# Product change notification

## Tina info output delay

PCN Document No.	2TLC010034J0201	Date of PCN:	2021-09-27
PCN issued by:	Elias Agrell	PCN valid as of:	2022-01-01
Product Manager:	Gustav Örnstedt	Obsolescence Date:	
R&D Manager:	Lars-Magnus Felth	Change Date:	2022-01-01
Products impacted:	Tina 3, Tina 7		
Impact on Form/Fit/Function:	<input type="checkbox"/> Form <input type="checkbox"/> Fit <input checked="" type="checkbox"/> Fctn	Impact on reliability:	<input type="checkbox"/> Y <input checked="" type="checkbox"/> N

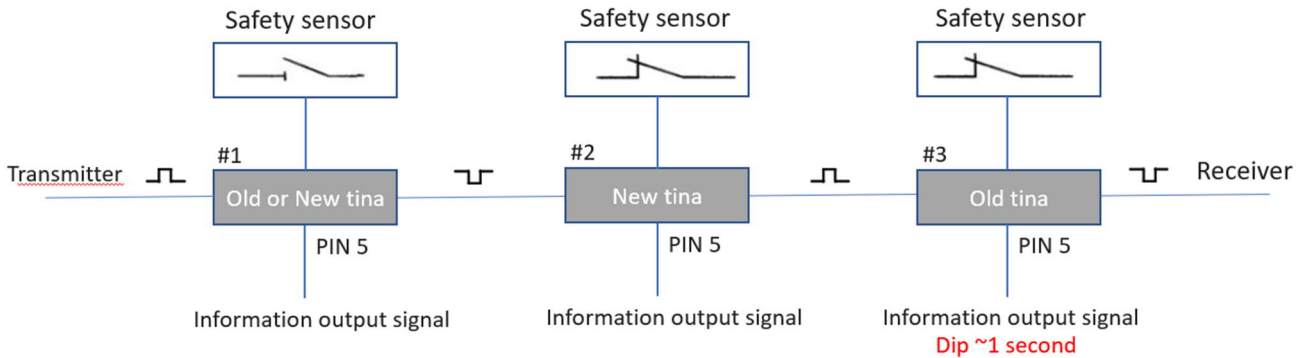
The non-safe information output signal is located on pin 5 on the affected products. The signal goes low when the safety sensor connected to it is deactivated and enters a safe state (e.g., an emergency stop).

Users of the products can experience that the information output signal goes low for ~1 second despite that the safety sensor is active. This phenomenon can in some cases occur if new products (produced 2022 or after) are mixed with old products (produced before 2022) in the same safety loop.

The phenomenon will occur if a Tina (#1) is deactivated by its safety sensor, which is followed by a new Tina (#2) and an old Tina (#3). Then the old Tina (#3) and the rest (#4 to #30) after in that loop will have the ~1 second dip in the information output signal.

Customers are recommended to analyze the dip/loss off the information signal in their application, when replacing old products with new products. If this behavior affects the application in a negative way can the solution be to:

- Apply a 1,5 second off delay filter on the receiver (e.g., PLC) of the information signal.
- Replace all old products in the safety loop with new products.
- Place all old Tina first in the safety loop, and the new Tina in the end.
